The Sizewell C Project

5.1 Consultation Report Appendices G.1 - G.8 Part G: Other Appendices

Appendix G.1 Scoping Opinion (June 2014)

SCOPING OPINION

Figure 1 - Map showing Proposed alternative Route

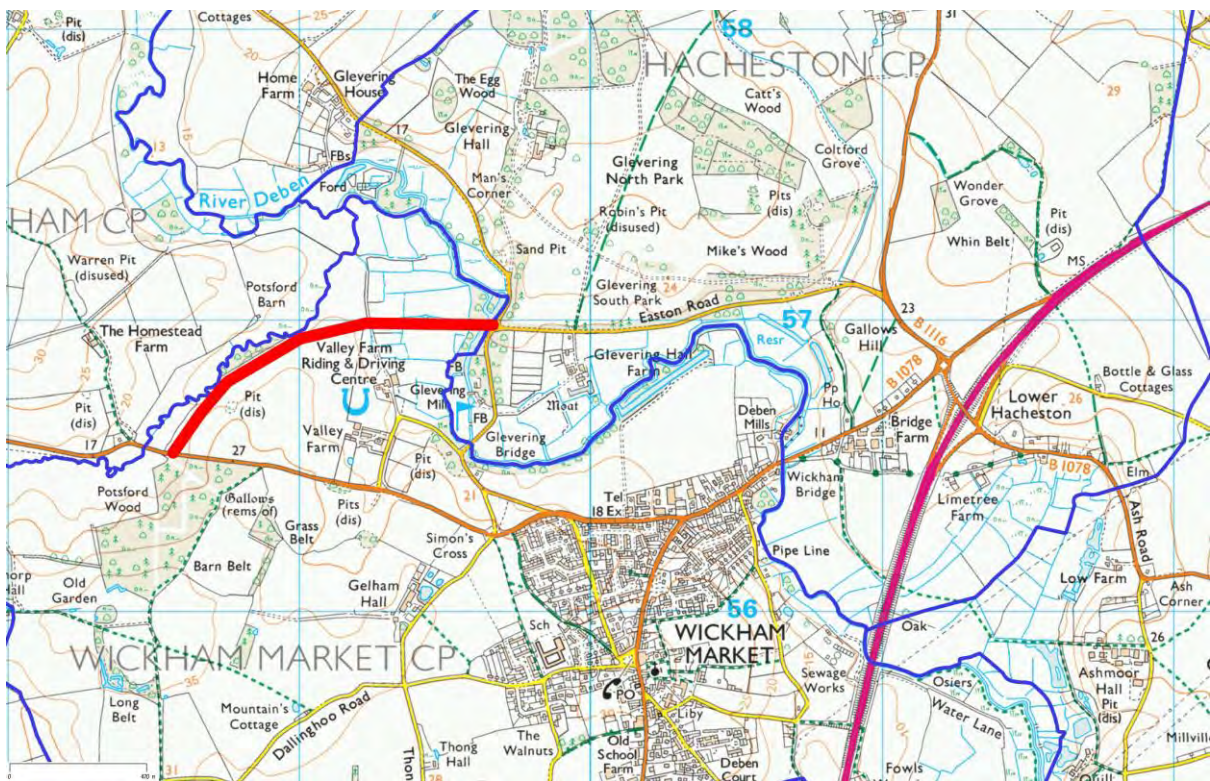
- 18.9. It must be remembered that drivers will only use the proposed diversion route if it is easier. This proposed route is significantly more difficult to drive.

- 18.10. A possible alternative new road is shown in red below:

This alternative has the significant benefit that road users will choose this route in preference to the existing road route as it will be quicker, a better road and an easier journey. The bridge/crossing over the River Deben will not be easy as it is on a flood plain however, once built it will form an extremely positive lasting legacy for Wickham Market as it will significantly reduce current HGV traffic through the north end of Wickham Market. It is appreciated that this option is not ideal from an environmental perspective and certainly does not have universal support within the Parish Council so if EDF could propose a better diversion route then that would be ideal. Alternatively, if there are significant environmental objections, the diversion route could be temporary, thus the river valley would be returned to its natural state after the project.
